LAKE WHATCOM WATER AND SEWER DISTRICT

REGULAR MEETING OF THE BOARD OF COMMISSIONERS

whatcom BR SEWER UNIT	LAKE WHA	TCOM WATER A AGENDA E Item 5.D	BILL	RICT
DATE SUBMITTED:	6/21/2018	MEETING DATE:	6/27/2018	
SUBJECT:				
TO: BOARD OF COMM	ISSIONERS	FROM: Melanie Wilson Er	Mankamyer, PE ngineering, LLC	
MANAGER	APPROVAL	BH		
ATTACHED DOCUMEN	TS	Local Gov Response Planning	tter to DOH which At Consistency forn e letter to Matt Aar and Development ages to Report	n .
		2.		
		3.		
TYPE OF ACTION REQU	IESTED		FORMAL ACTION/ MOTION	INFORMATIONAL /OTHER

The District submitted its Water System Comprehensive Plan Update to various agencies for review in December 2017. We received approval of the Plan from the Whatcom County Engineer and the Whatcom County Health Officer. We received comments from Washington State Department of Health (DOH) and Whatcom County Planning and Development (Planning) that required minor changes and corrections to the Plan. We have made those changes and have completed our response letters to DOH and Planning - these are attached with the text changes shown as redlines.

Figure 1. Fate and Transport of Phosphorus in Septic System Effluent.

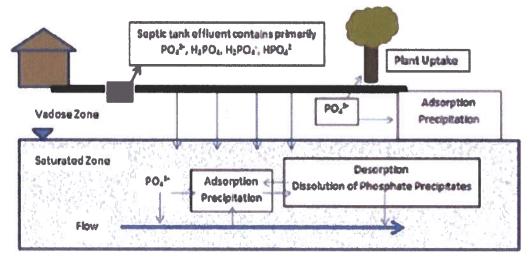
WCHD commented that the study results did not appear to substantiate the report conclusions because the following factors were not considered:
